PlanGrid Task Report - Jan 27, 2025

L05549_RELO Simpsonville FSU (SC)

Simpsonville, South Carolina

#290 [REFG 505] [NEW] WIC door sweep vs threshold.

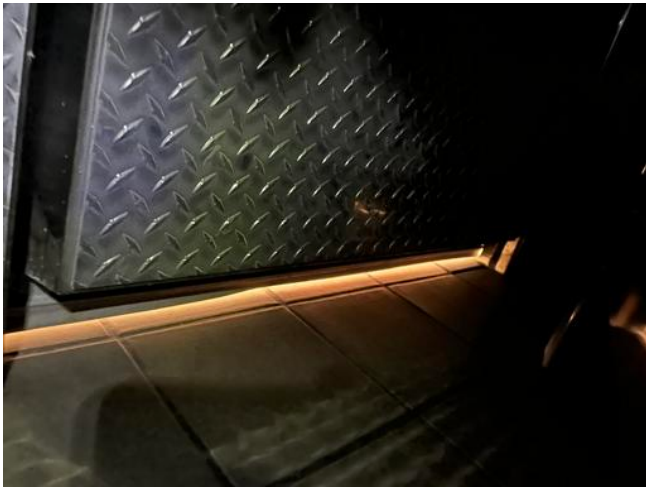
WIC door sweep is not sealed tightly with threshold when door is closed. Only translucent light should be present

IMG_6771

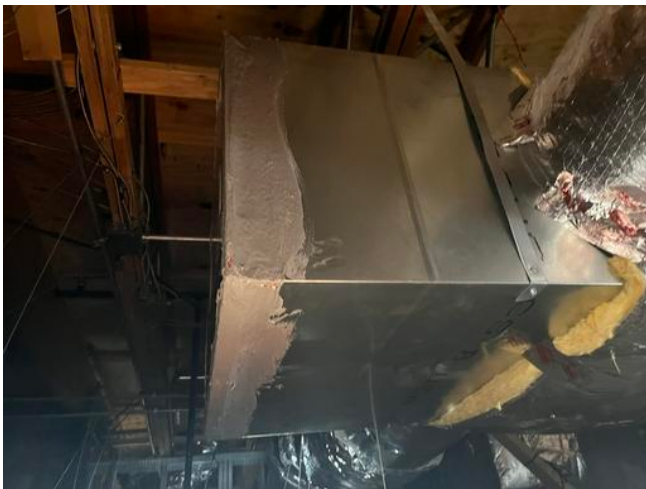
AC1, AC2, AC3 have exposed sheet metal. Supply & return ductwork in many spots are missing insulation. Recommend mechanical go through each duct run to ensure all sheet metal is insulated, and all insulation seams are taped.
